2.3 Radiation Monitoring Systems

The information in this section of the ABWR DCD, including all subsections, tables, and figures, is incorporated by reference with the following departures.

STD DEP T1 2.3-1 (Figure 2.3.1)

Figure 2.3.1 Process Radiation Monitoring System Control Interface Diagram

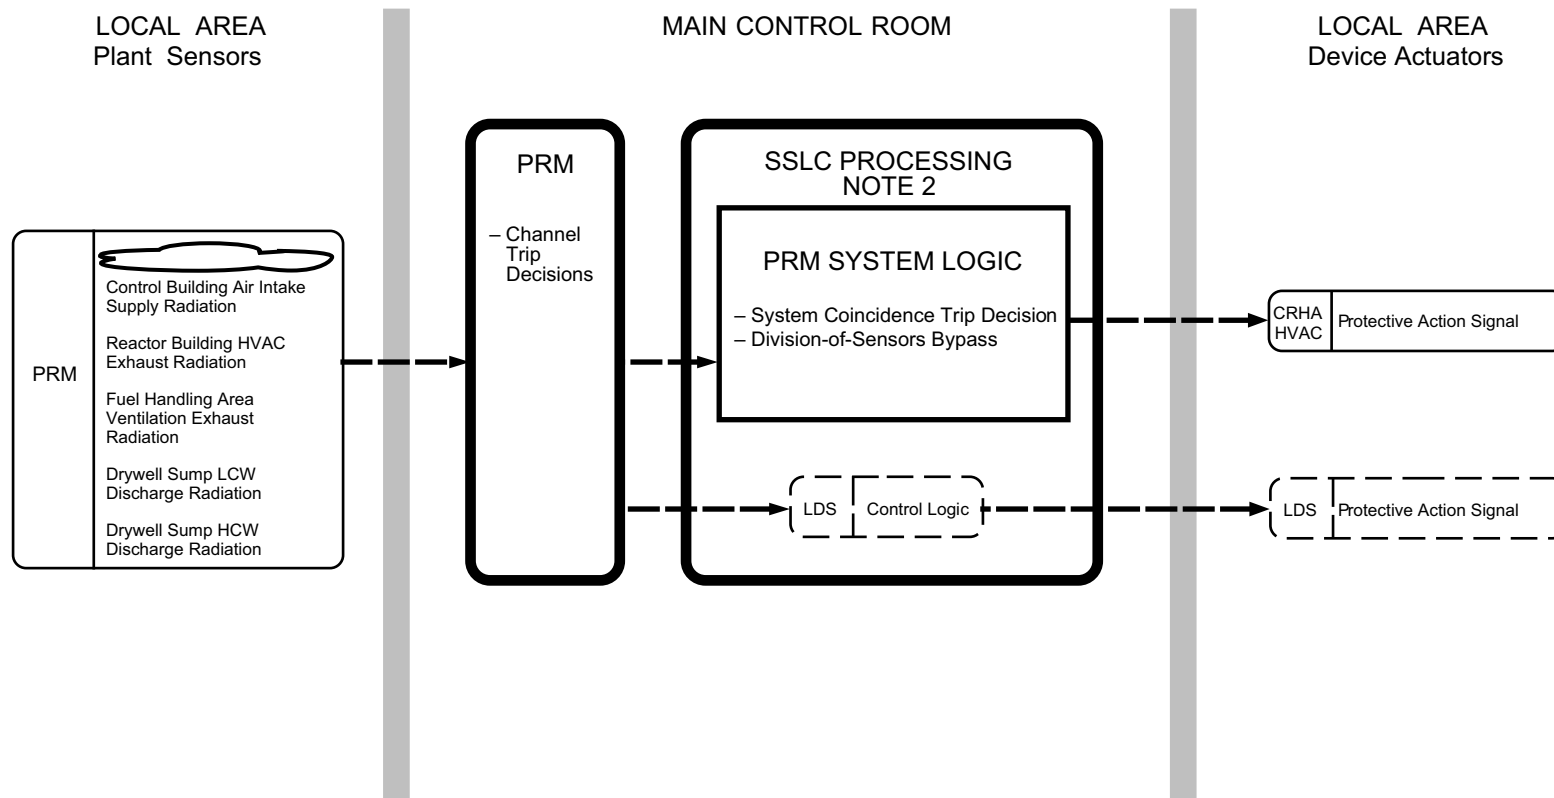
STD DEP T1 2.3-1

Portions of the PRM System are classified as Class 1E safety-related (items 42 through 5 below); the remainder are classified as non-safety-related.
